PRESENTATION TO CITY COUNCILPAST SITUATION

A GROUP OF RESIDENTS OF MERRYWOOD SUBDIVISION AGREED ON NOVEMBER 5, 198⁴~~5~~, TO A PROPOSAL BROUGHT FORWARD BY THE MAYOR AND CITY ENGINEER OF ONESBCRO TO PROVIDE RELIEF FROM INADEQUATE SURFACE WATER DRAINAGE IN THE SUBDIVISION.

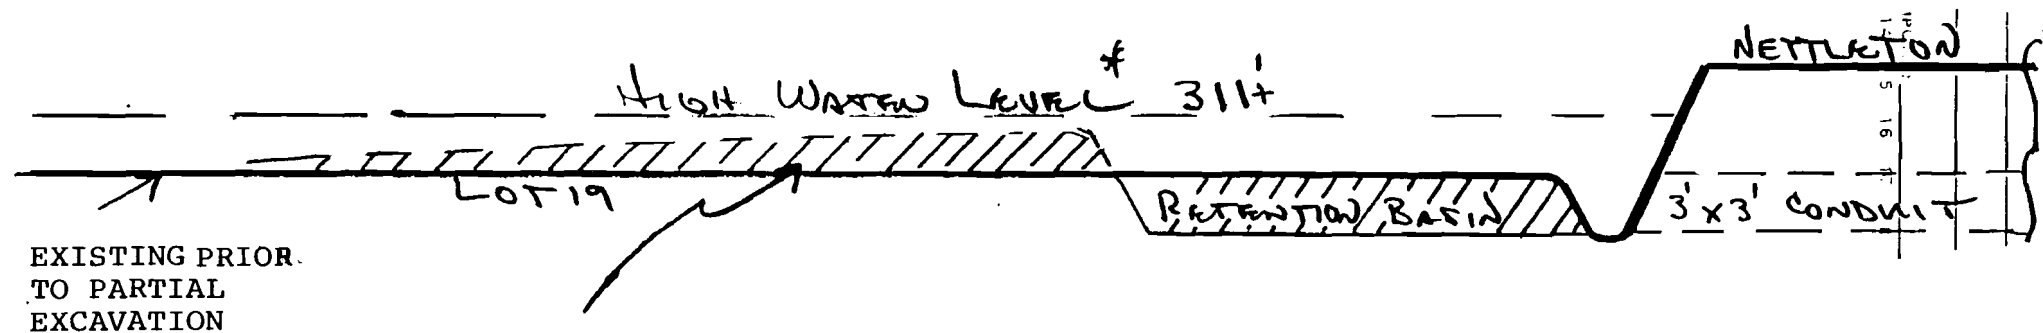
OUR AND YOUR EFFORT IN PART LAST NOVEMBER WAS TO CORRECT THIS SITUATION. BUT TO TAKE EARTH FROM ONE POINT (THE BASIN) AND DISPOSIT IT IN AN ADJACENT AREA THAT FLOODS TO THE SAME LEVELS, DOES ABSOLUTELY NOTHING TO REDUCE THE FLOOD THREAT TO THE AREA HOMES, MUCH LESS INCREASE WATER RETENTION CAPABILITY.

TO DO THIS IS INTERPRETED TO BE A VIOLATION OF CITY ORDINANCE 21-15 E II.

* NEAREST HOUSE FINISHED FLOOR LEVEL - 310.53'

- FILL FROM RETENTION BASIN
BEING USED TO RAISE LOT 19 LEVEL - EQUAL VOLUME OF EARTH
- NO IMPROVEMENT IN HOLD-UP TIME

THEREFORE: THE FILL DIRT PLUS POTENTIAL HOME FOUNDATIONS WILL WORSEN
THREAT, NOT IMPROVE.

MERRYWOOD DRAINAGE3 x 3

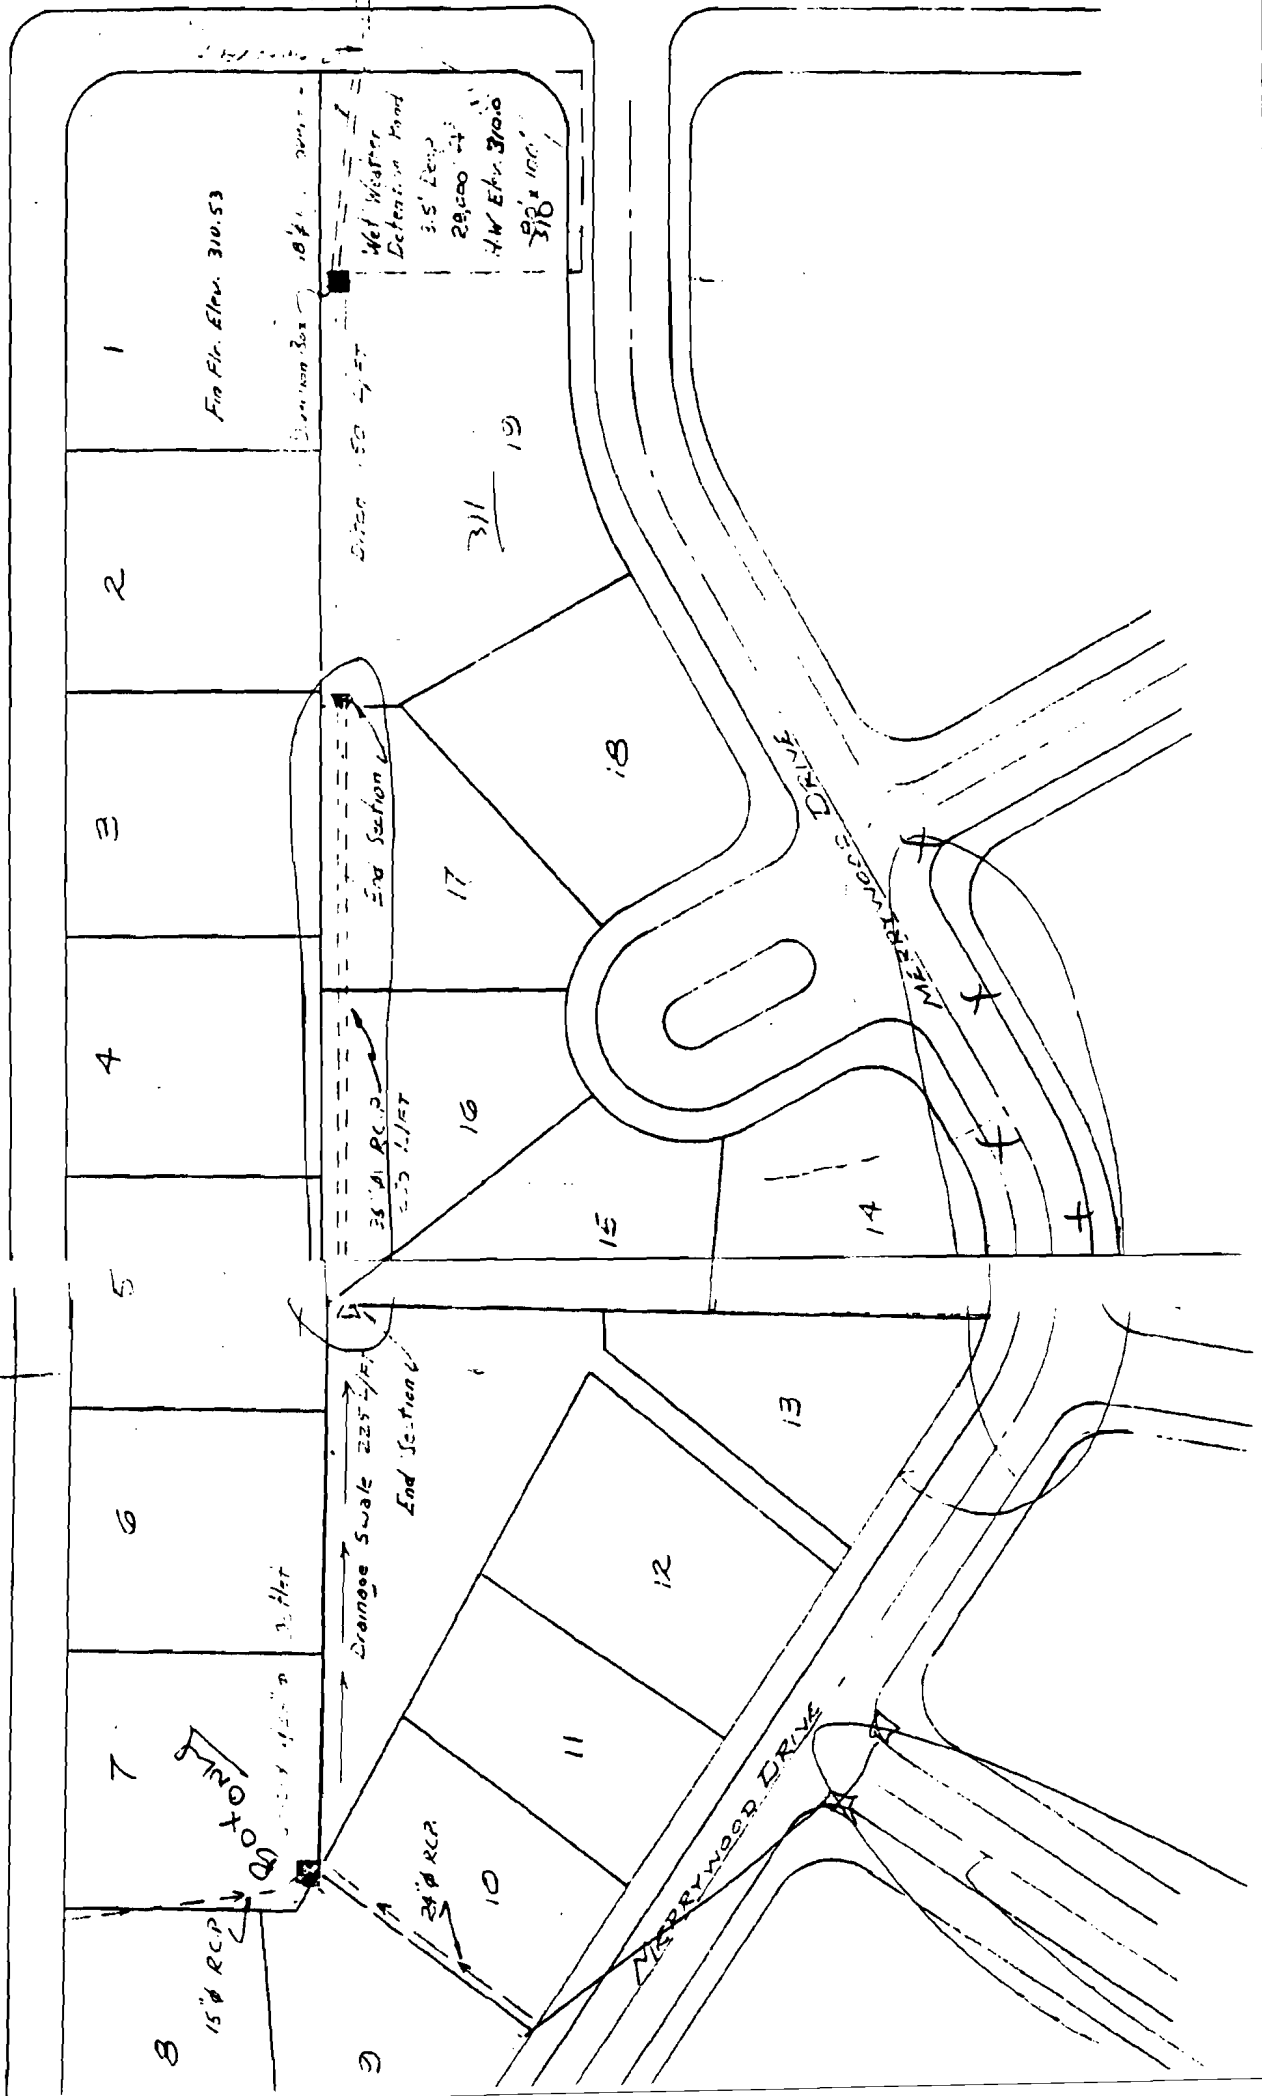
- City Does NOT want 4x4?
